**Streamlined Remediation System Evaluation**  
**Wash King Laundry Superfund Site**  
**Pleasant Plains Township, Michigan**

## **WASH KING LAUNDRY SITE PLEASANT PLAINS TOWNSHIP, LAKE COUNTY, MICHIGAN**

Report of the Streamlined Remediation System Evaluation  
Conference Call Conducted for the Wash King Laundry Site  
July 26, 2010

Revised Report  
February 18, 2011

FIGURE 13

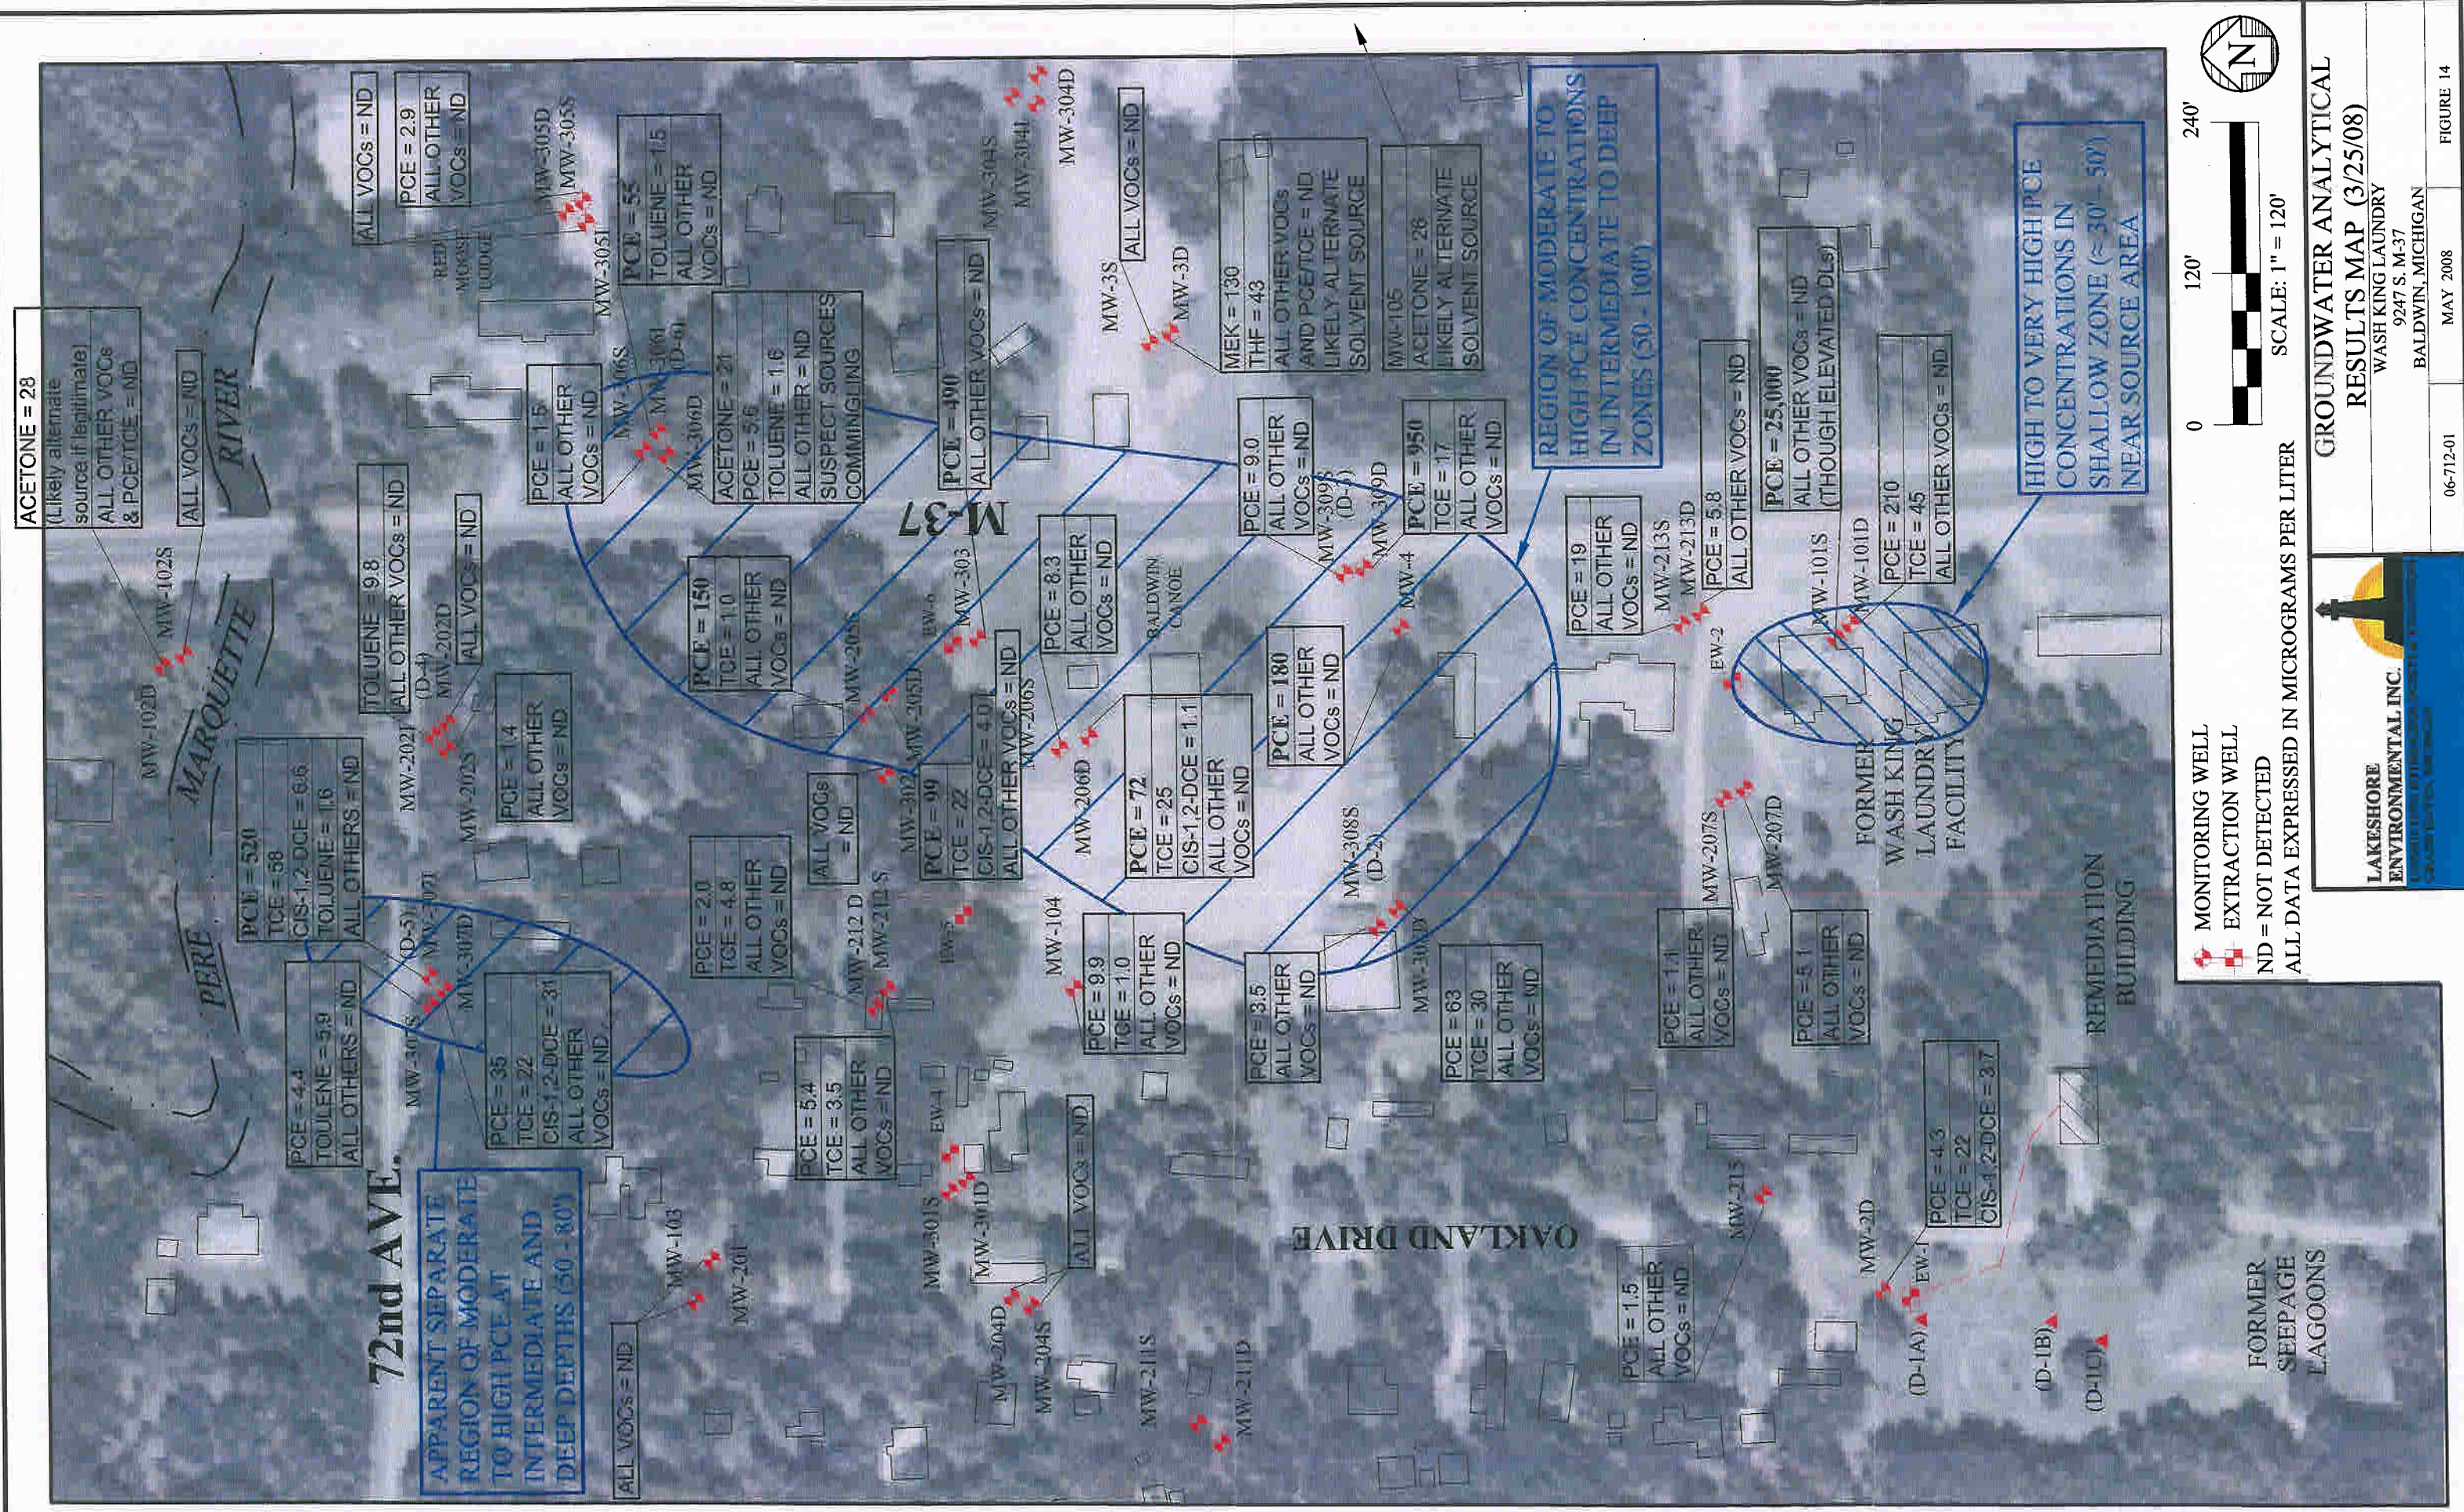
Groundwater flow under non-pumping and pumping conditions in 2008 (prior to the installation of EW-7) are presented in Figures 11 and 13 (see Attachment A). Figure 11 illustrates that groundwater flows to the north, north-east toward the river, and the slight curvature of the contours in the vicinity of EW-6 may result from incomplete aquifer recovery prior to collecting the non-pumping round of water levels. Figure 13 provides the site team's depiction of the horizontal capture zone. The RSE-lite team evaluated the water levels and potentiometric surface map and generally agrees with the interpreted potentiometric surface map and extent of the capture zone in the vicinity of EW-4, EW-5, and EW-6. In general, when evaluating capture in the area of these wells, the intermediate and deep wells should generally be used because that is the interval where most of the contamination is present. There are a few instances where water levels from individual wells do not appear accurate based on water level measurements from surrounding wells or other wells in the well cluster. MW-202D and MW-206D are a few examples. The inconsistencies appear to occur during each water level event, suggesting that a survey error may be the cause.

The capture zones in the vicinities of EW-1 and EW-2 is based on limited data. The extent of capture from EW-2 may be overestimated in Figure 13. Use of water level data from the new 400 series monitoring wells will provide more information to interpret capture and extraction from EW-7, which is now occurring, will greatly improve capture in this area. Based on the observed drawdown and the background water hydraulic gradient, the interpreted capture zone near EW-1 is likely a reasonable approximation.

FIGURE 26 c

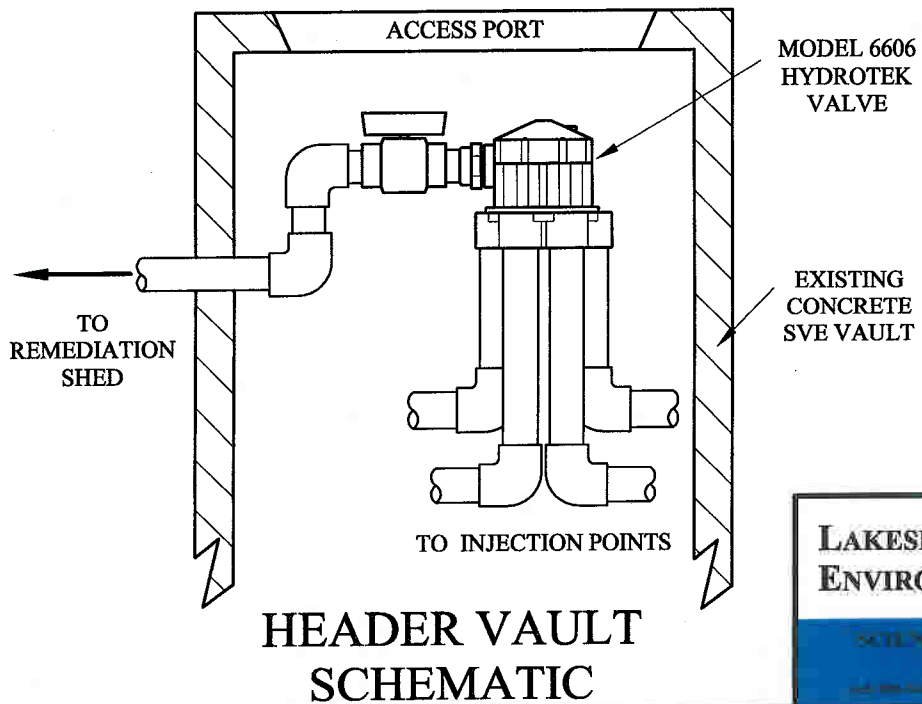
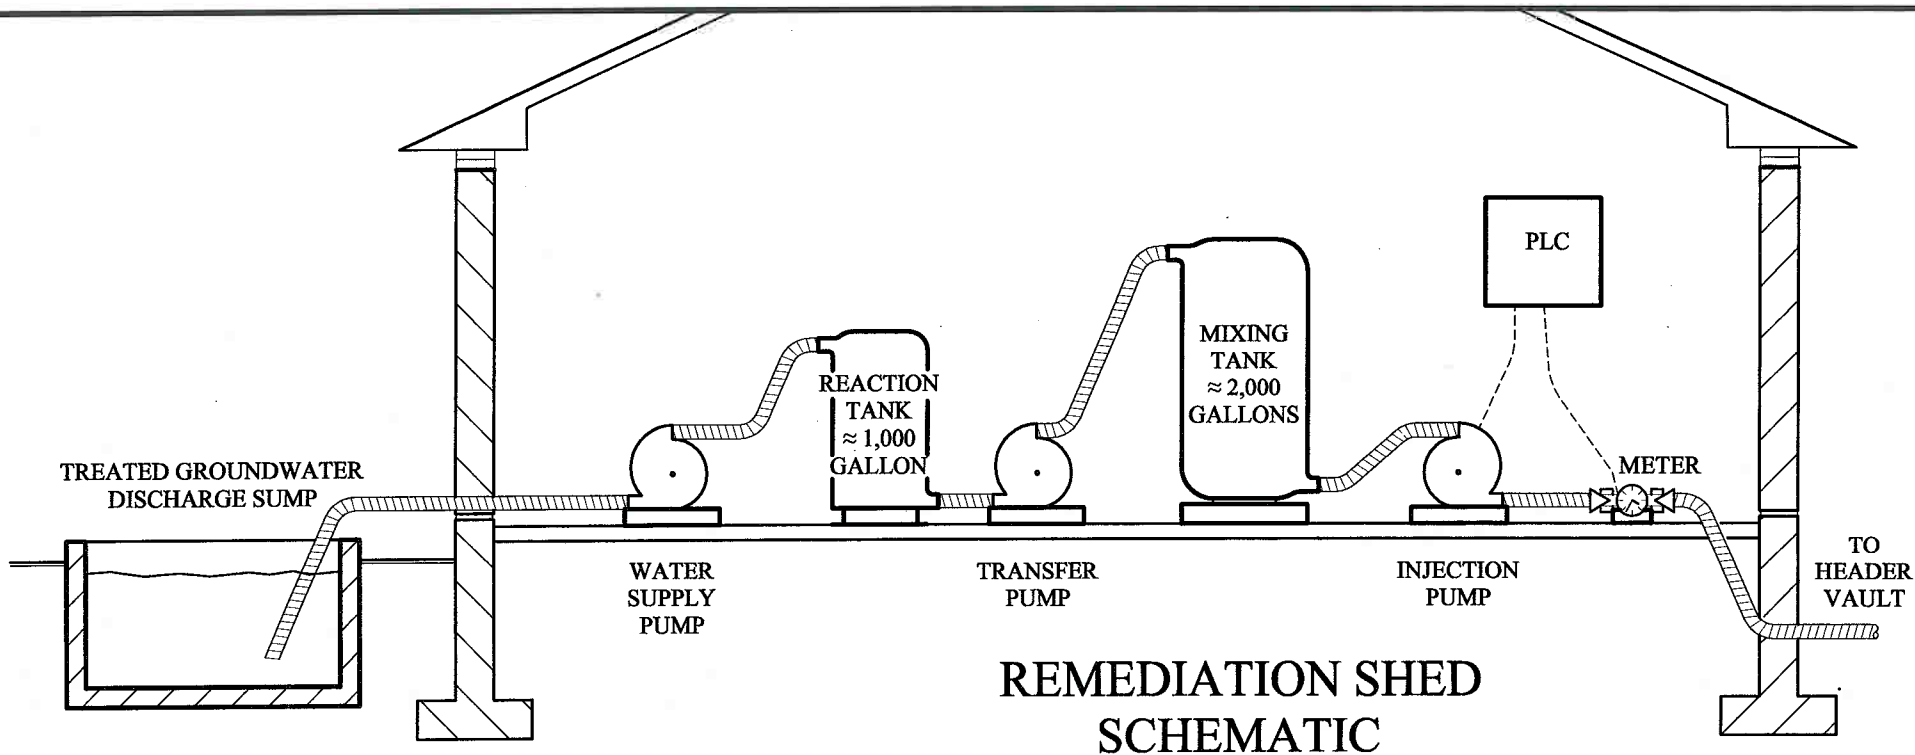
The as-built schematics for the bioremediation system are shown in Figures 26C, 27, and 28 (see Attachment A). The RSE-lite team has little additional information on system operation and performance and therefore cannot comment on system performance or effectiveness.
